**Subject:** U-Scan Genesis Bill Acceptor Hinge and Lanyard Field Replacement

**Issue**

There have been some reports of the Bill Acceptor hinge bracket breaking when excessive downward force is applied. This issue applies to older versions of the Genesis robot with the backload Bill Acceptor bracket which does not have the top plunger latch and/or lanyard restraint.

Unit without Lanyard or Plunger  
(Needs Upgrade)

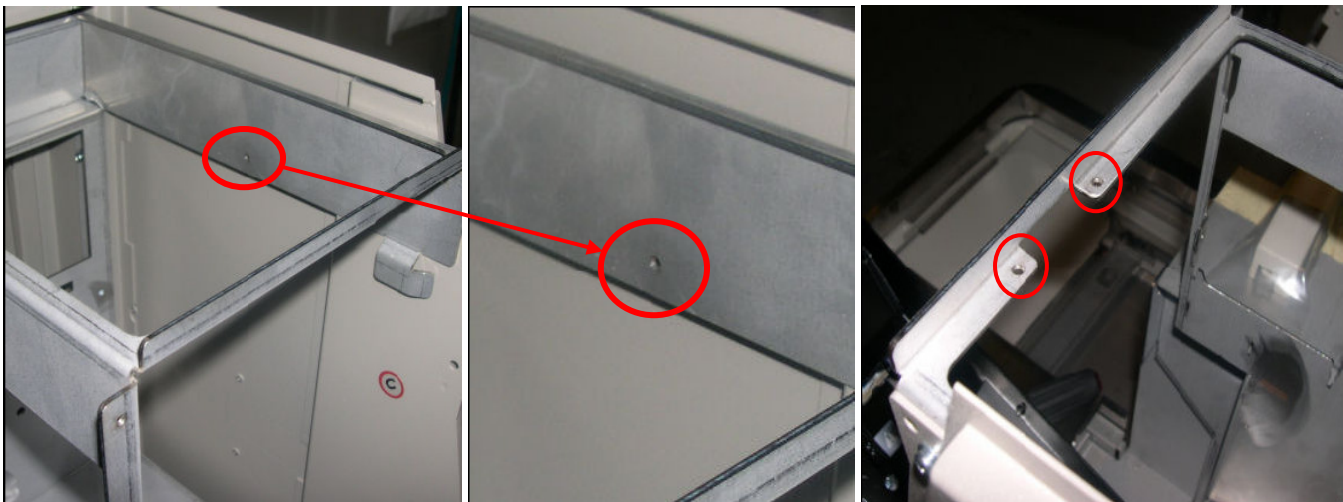
- If the Robot is missing the Plunger or Lanyard but has the appropriate threaded holes, the unit needs the upgrade. Depending on your CashCode unit you will need field kit 11002376 or 11002377.
